SPARKLE STREET

STAGE 1 ROAD SAFETY AUDIT RESPONSE REPORT

SPARKLE STREET, MANCHESTER PROPOSED S278 HIGHWAY WORKS

STAGE 1 ROAD SAFETY AUDIT

6.0 PHOTOGRAPHS

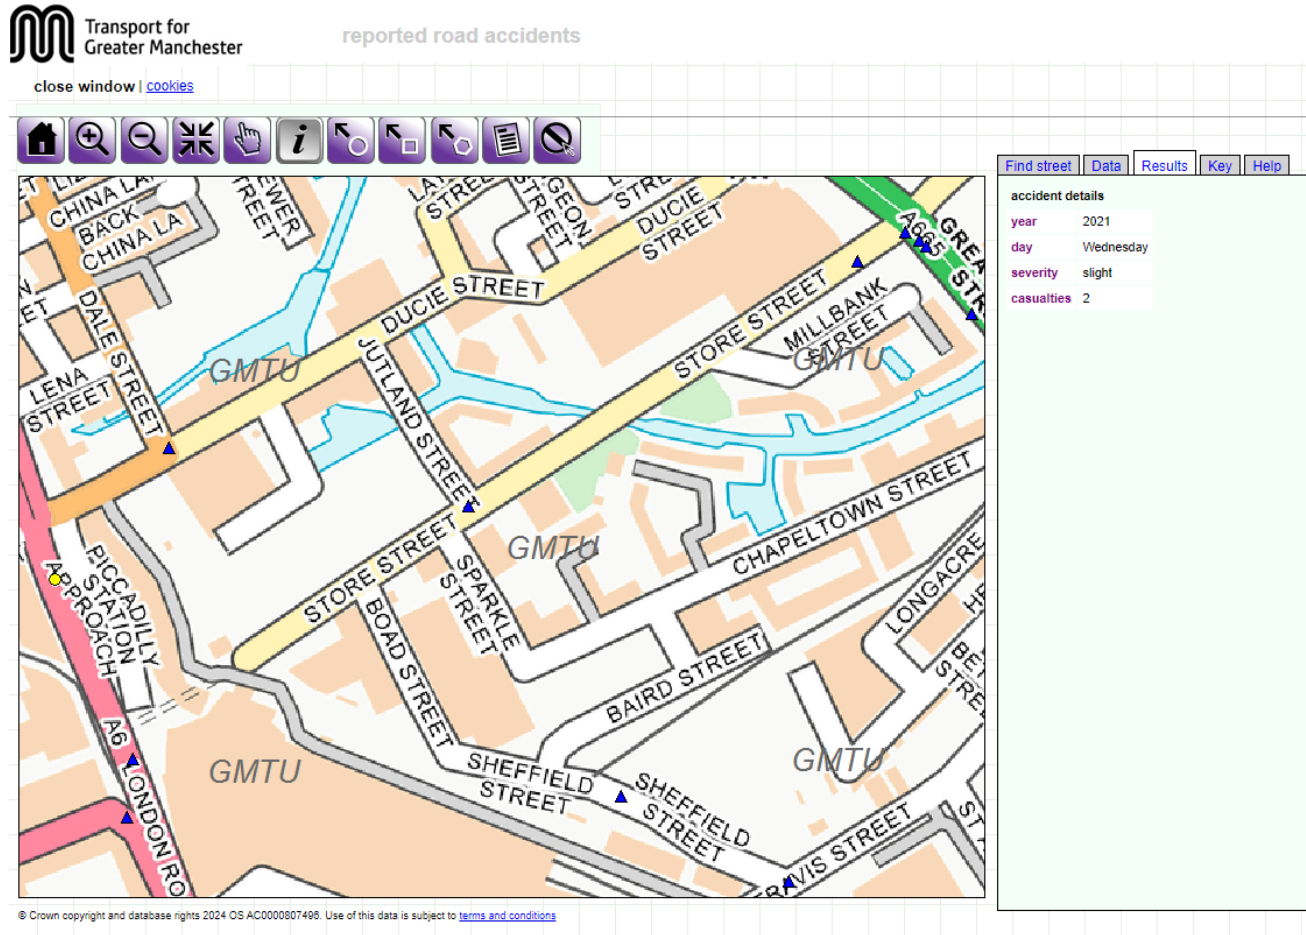
2.1.1 Location: Proposed kerbed build-out on Store Street

The drawings do not show any reflective bollards or similar on the build-outs on Store Street. Omission of appropriate street furniture highlighting the build-outs to approaching drivers may result in vehicles colliding with the build-outs. Whilst it is noted that vehicles parked in the parking bays to the east will offer some protection of the build-outs, there will be times when there are no vehicles parked in the parking bays and drivers may approach the build-outs whilst over-running the parking bays.

This issue is exacerbated by the location of the centre line road marking on Store Street which guides vehicles towards the proposed build-outs.

2.4.1 Location: Existing uncontrolled pedestrian crossings on the Sparkle Street

It was observed during the site visit that the existing uncontrolled pedestrian crossings on Sparkle Street do not have the required minimum depth of tactile paving across the whole width of the dropped kerbs for in-line type uncontrolled crossings. The audit team note that the minimum depth of tactile paving for in-line type crossings is generally 1200mm. A reduced depth of tactile paving results in a lack of appropriate warning for visually impaired

Additionally, it was observed that the kerb upstand at the existing uncontrolled pedestrian crossings on Sparkle Street were in excess of 6mm. Generally, the kerb upstand at uncontrolled pedestrian crossings is between 0mm and 6mm. The excessive kerb upstand may increase the risk of pedestrian trips/falls and may create manoeuvrability issues for those with pushchairs, wheelchairs and mobility scooters.

It is recommended that appropriate street furniture, such as reflective bollards, should be provided on the proposed build-outs on Store Street. Additionally, it is recommended that the centre line road marking on Store Street is relocated to guide vehicles away from the proposed build-outs.

It is recommended that the tactile paving layout should be amended to provide a minimum depth of 1200mm tactile paving across the whole width of the dropped kerbs at the in-line uncontrolled crossings and that the kerb upstand at the existing uncontrolled pedestrian crossings is reduced to between 0mm and 6mm.
